UNITED STATES PATENT AND TRADEMARK OFFICE

APPLICATION NO.	FILING DATE	FIRST NAMED INVENTOR	ATTORNEY DOCKET NO.	CONFIRMATION NO.
10/694,147	10/27/2003	Nicholas Want	AMD-104US	3026
23122	7590	03/17/2006	EXAMINER	
RATNERPRESTIA P O BOX 980 VALLEY FORGE, PA 19482-0980			CHAN, KO HUNG	
			ART UNIT	PAPER NUMBER
			3632	
DATE MAILED: 03/17/2006

Office Action Summary	Application No. 10/694,147	Applicant(s) WANT ET AL.	
	Examiner Korie H. Chan	Art Unit 3632

DETAILED ACTION

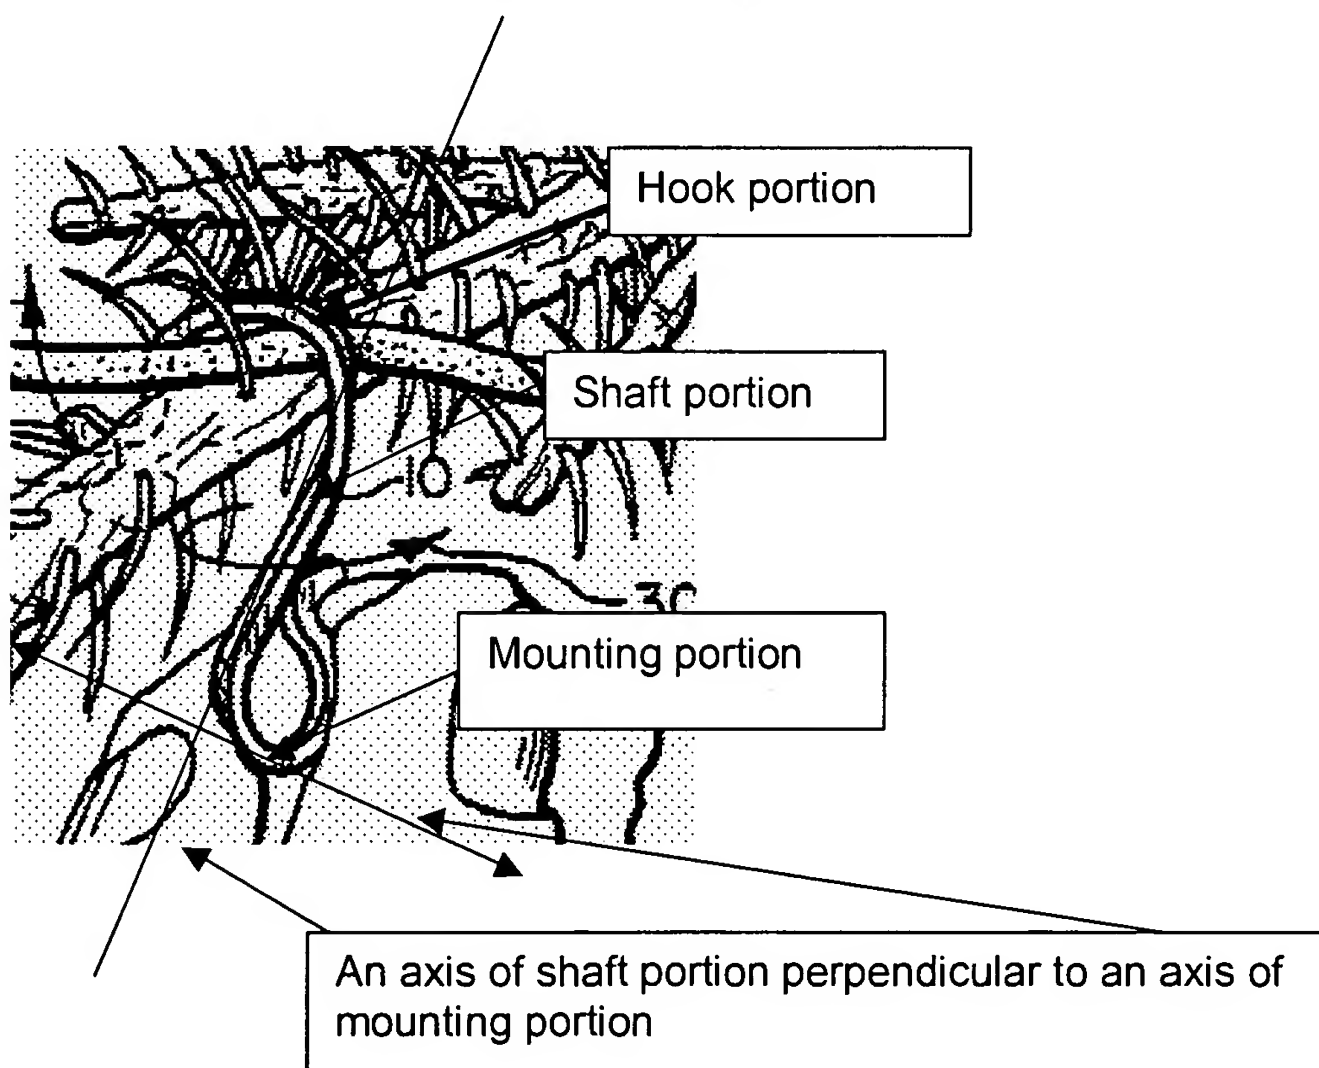
Claims 1-3 and 6-12 are rejected under 35 U.S.C. 102(b) as being anticipated by Swenson et al (US patent no. 5,575,446). Swenson disclosed all the claimed features of applicant's invention as demonstrated below.

In this case, Swenson's hanger is capable of performing the intended use of supporting a medical device of the thoracic cavity drainage system type.

Applicant's argument filed 1/5/2006 have been fully considered but are found not persuasive. Regarding Swenson et al, applicant argues that Swenson does not disclose "hook portion is positionable in a plane of the mounting portion. Examiner respectfully disagrees. Swenson in figure 3 clearly shows the hook portion 15 positioned in a plane of the mounting portion (12). And the longitudinal axis of the mounting portion as illustrated above is perpendicular to an axis of the shaft. Accordingly, the rejection stands.

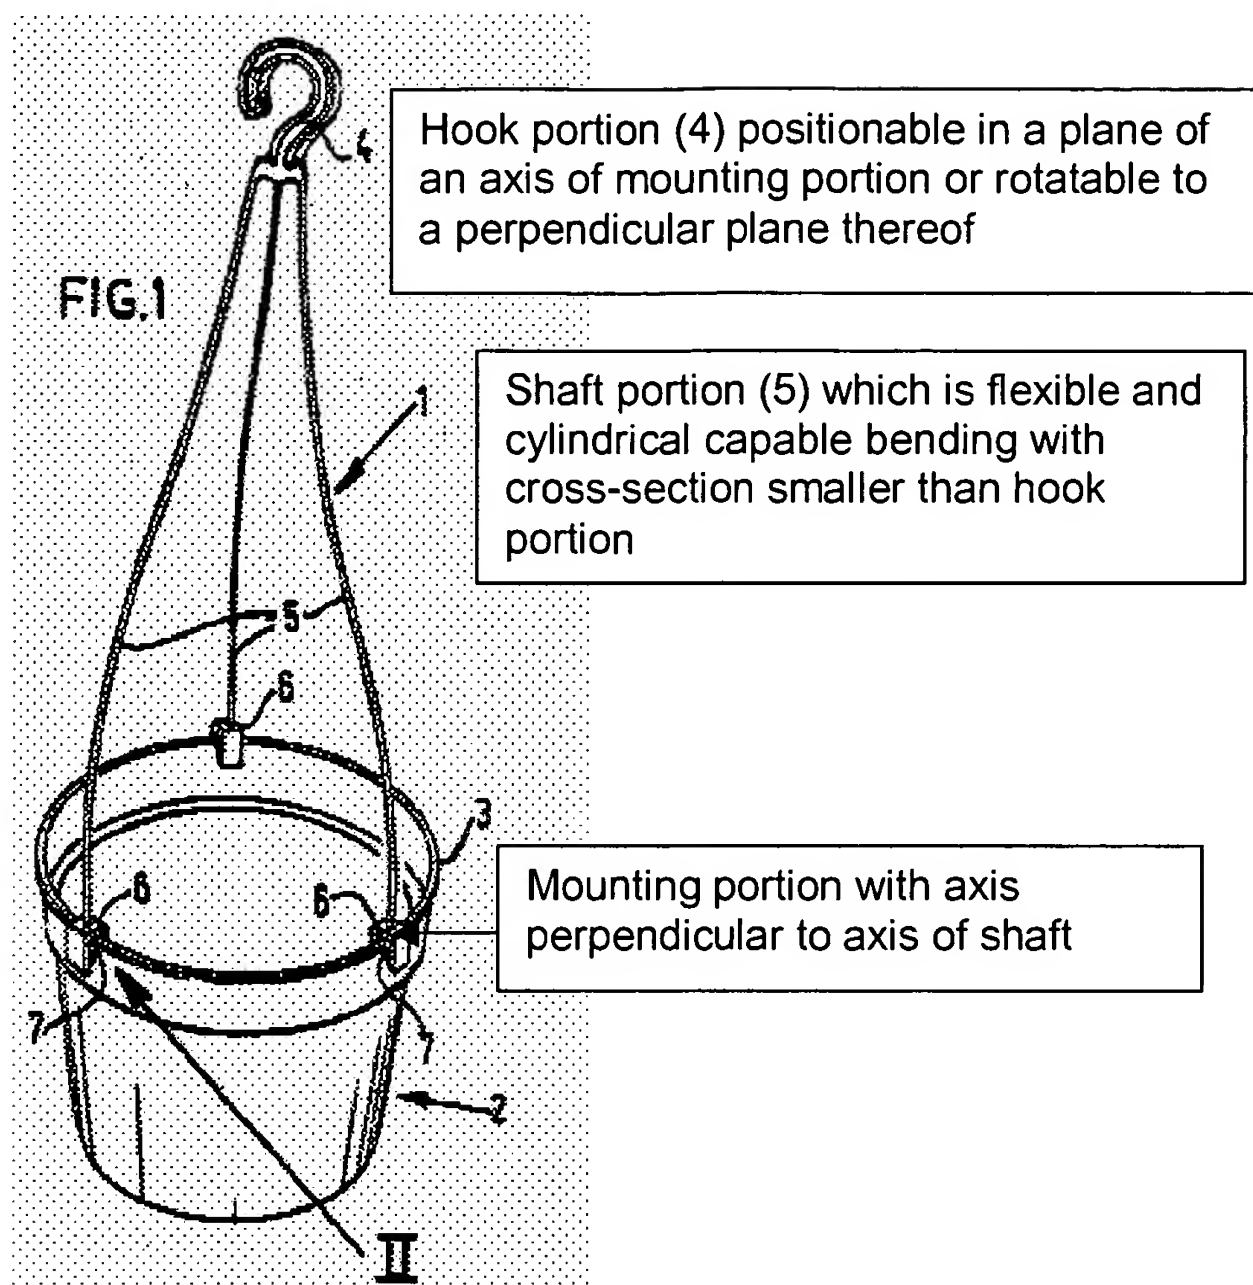
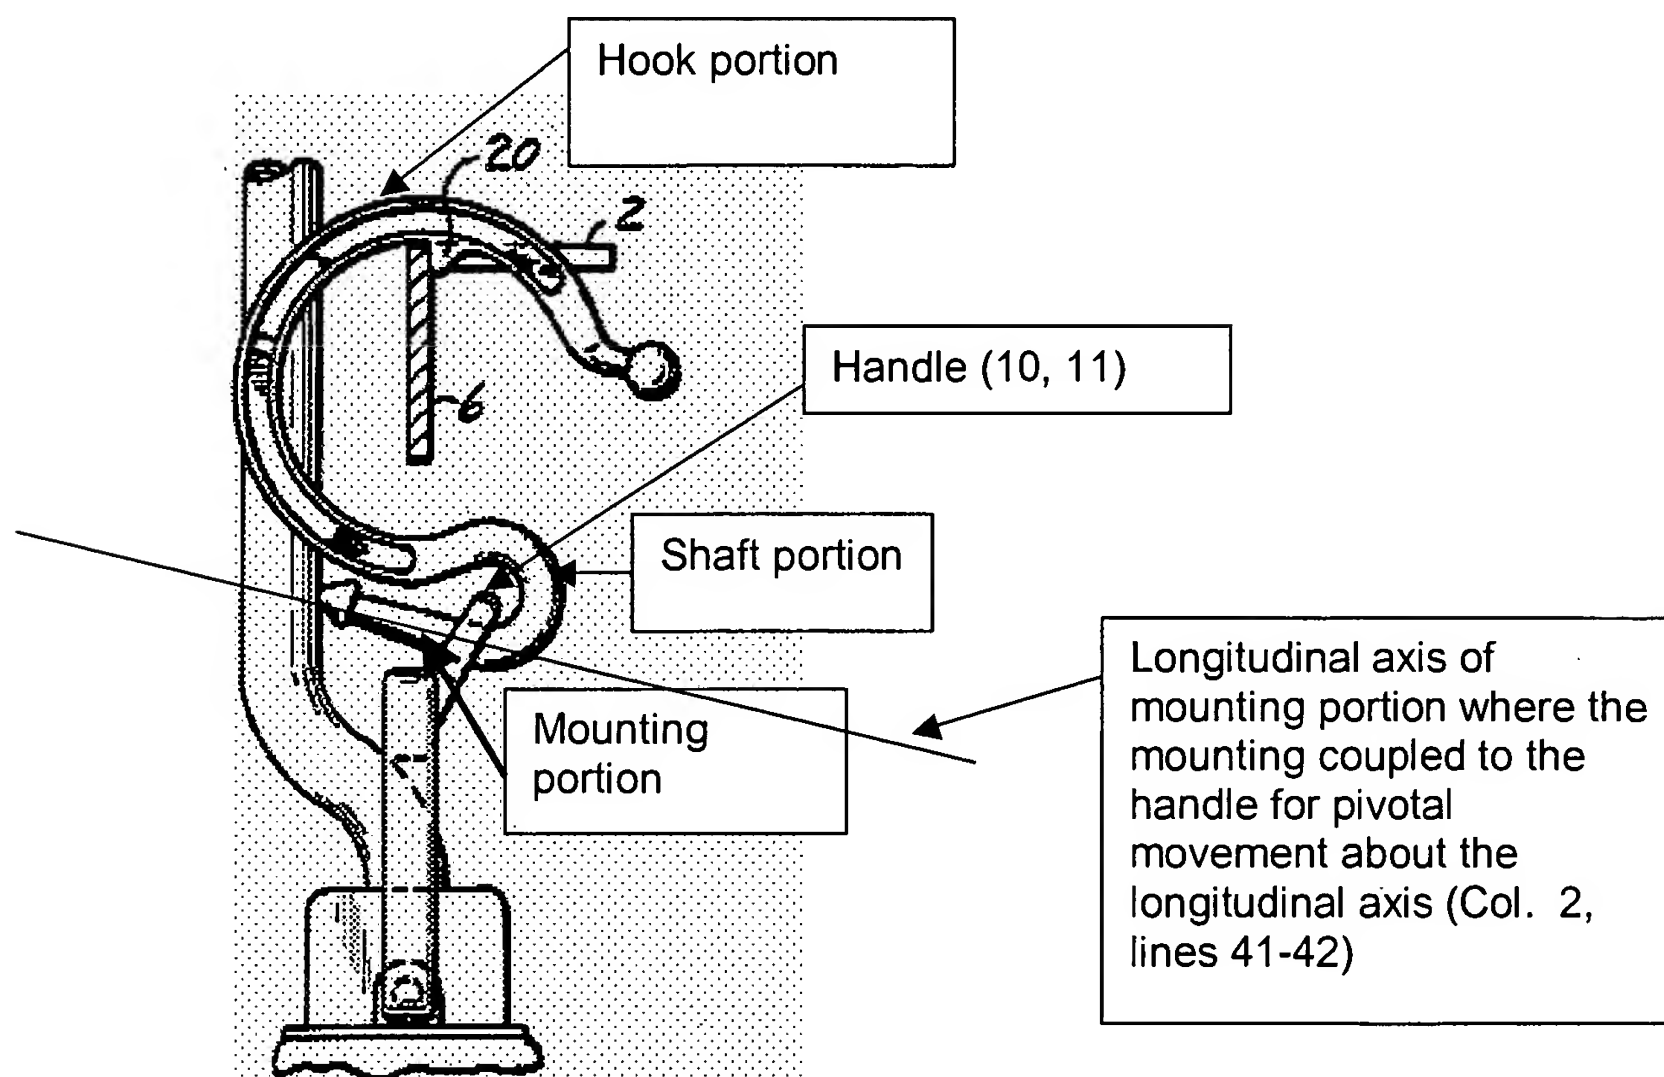
Claims 1-12 are rejected under 35 U.S.C. 102(b) as being anticipated by Wijsman (US patent no. 4,440,371). Wijsman disclosed all the claimed features of applicant's invention as demonstrated below.

Again regarding applicant's intended use language set forth in the preamble "for medical device" such as "a fluid recovery system" as in claim 9 or "thoracic cavity drainage system" is not accorded with patentable weight. Wijsman's hanger is capable of performing the intended use function claimed.

Applicant's argument filed 1/5/2006 have been fully considered but are found not persuasive. Regarding Wijsman, applicant argues that Wijsman does not disclose "mounting portion...configured for mounting said apparatus for movement with respect to the medical device" where Wijsman does not show the carrying members (6) are adapted for movement with respect to the pot. Examiner respectfully disagrees.

Wijsman shows the mounting portion (item 6) is configured for mounting the apparatus (the hanger) by gripping the pot and when the pot is gripped, the apparatus for hanging can be moved via the flexible shaft (1) and the fact the pot is gripped by item 6 with respect to the device (or pot).

Applicant argues that Wijsman's carrying member (item 6) does not have longitudinal axis or axis of rotation. Examiner respectfully disagrees. The "longitudinal axis" is not claimed as "axis of rotation" in claims 1-12 and such argument is irrelevant. Regarding longitudinal axis, the carrying member 6 of Wijsman certainly has a longitudinal axis. An axis is an imaginary line through the device. Wijsman's longitudinal axis is any horizontal axis extending through the item 6 along the plane of the hook (4) which also meets applicant's limitation that "hook portion is positionable in a plane of the mounting portion. Accordingly, the rejection stands.

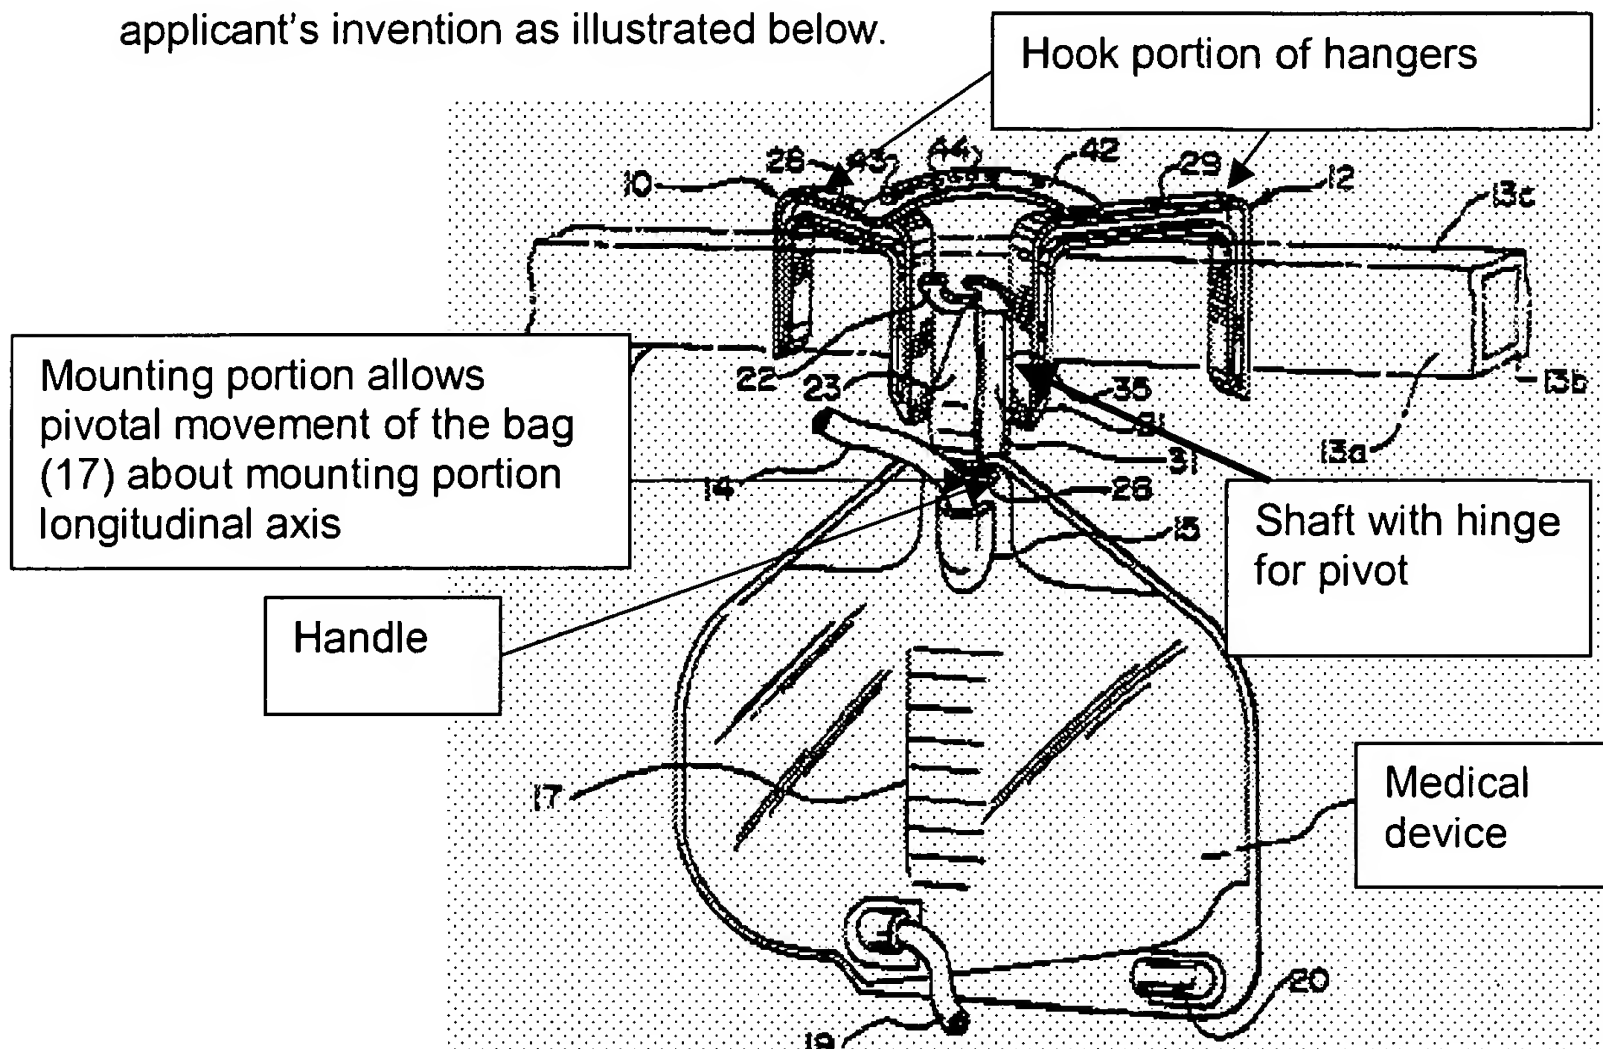
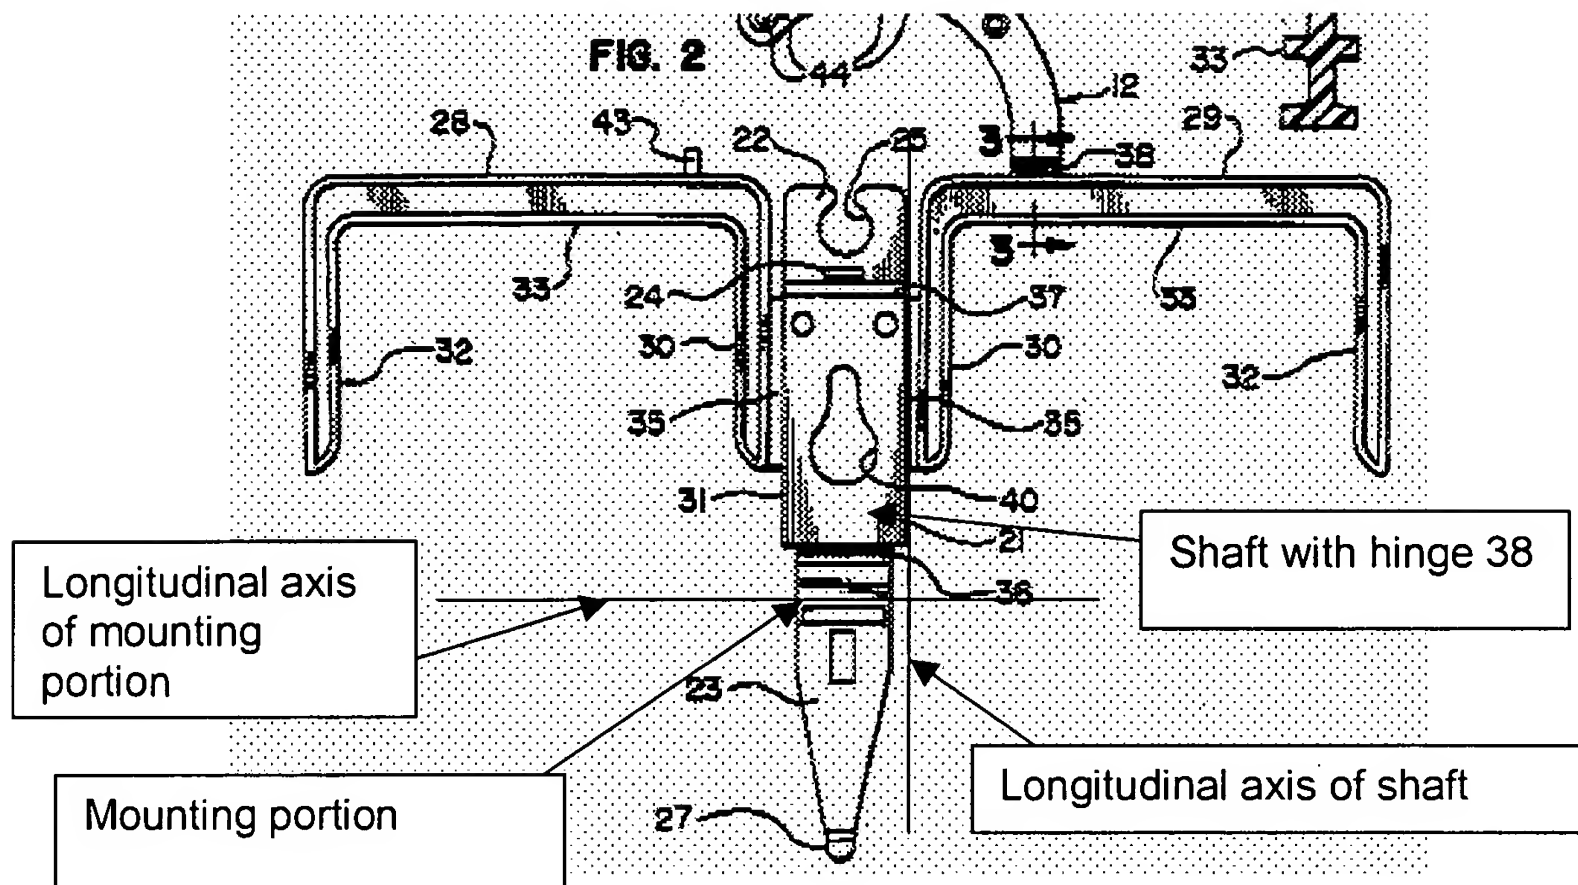
Claims 13-15 and 18 are rejected under 35 U.S.C. 102(b) as being anticipated by Rhodes (US patent no. 5,373,799). Rhodes disclosed all the claimed features of applicant's invention as illustrated below.

Applicant's argument filed 1/5/2006 have been fully considered but are found not persuasive. Regarding Rhodes, applicant argues that Rhodes does not disclose "mounting portion coupled to an end portion of said elongated shaft and coupled for pivotal movement with respect to the medical device about a longitudinal axis of the mounting portion" and "elongated shaft of said hanger configured to permit rotation of said hook portion with respect to said mounting portion of said hanger about a longitudinal axis of the elongated shaft". Examiner again respectfully disagrees.

Rhodes clearly discloses "mounting portion (the portion of the strap where the handle of medical bag is hung) coupled to an end portion of said elongated shaft (21 along with its hinge 38) and coupled for pivotal movement with respect to the medical device about a longitudinal axis of the mounting portion (the handle of the medical bag and the strap mounting portion are foldable or pivotable about each other at the longitudinal axis, see illustration above)" and "elongated shaft (21 along with its hinge 38) of said hanger

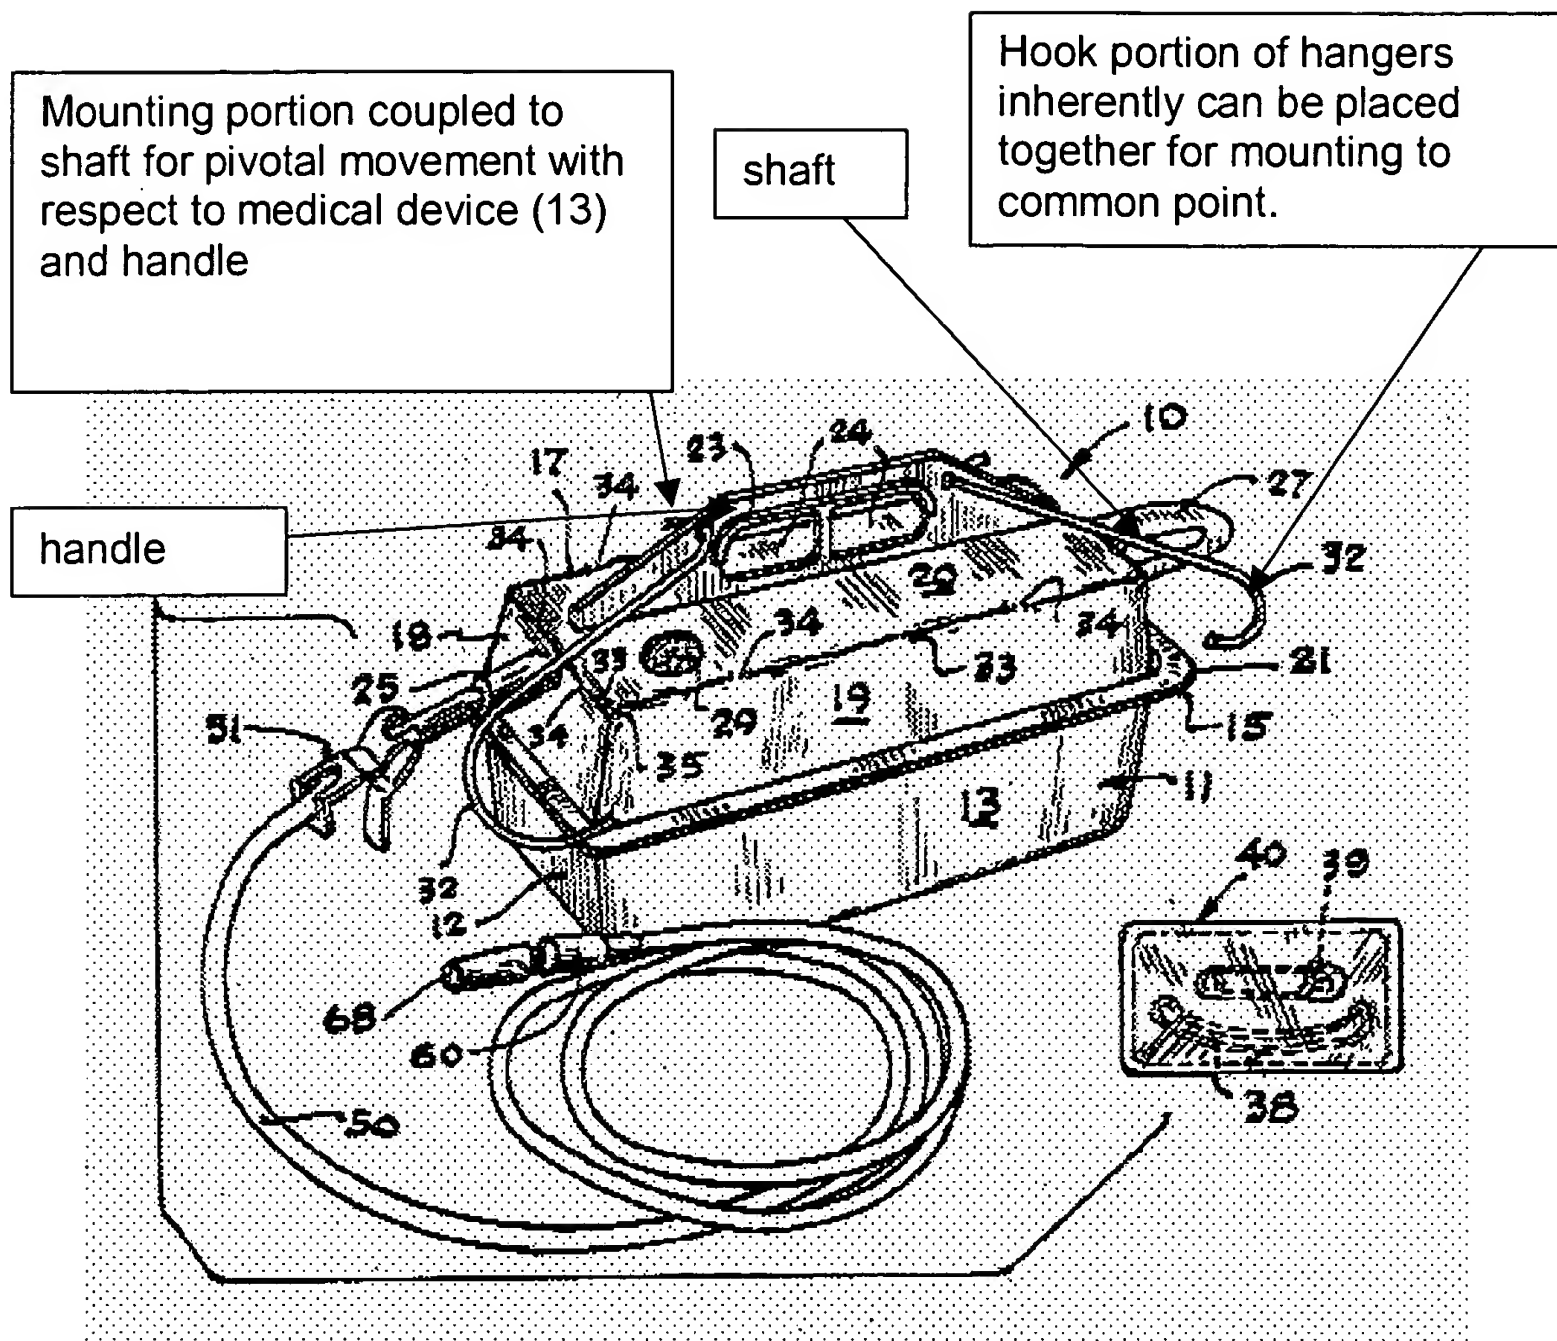
Claims 19, 21 and 22 are rejected under 35 U.S.C. 103(a) as being unpatentable over Chittenden et al (US patent no. 3,690,315) in view of Koresko (US patent no. 5,224,607). Chittenden et al disclosed all the claimed features of applicant's invention (as illustrated below) except for the hook portion rotate with respect to mounting portion. Koresko teaches in a hanger of providing a hook portion (3) and mounting portion (5) wherein the hook portion rotates relative to the mounting portion to overcome prior art deficiencies by allowing for "capture of multi-positioned supports" (col. 4, lines 14-20) . It would have been obvious to one of ordinary skill in the art to have made Chittenden's hook portion rotatable relative to the mounting portion to permit capture of multi-positioned supports as taught to be desirable by Koresko.
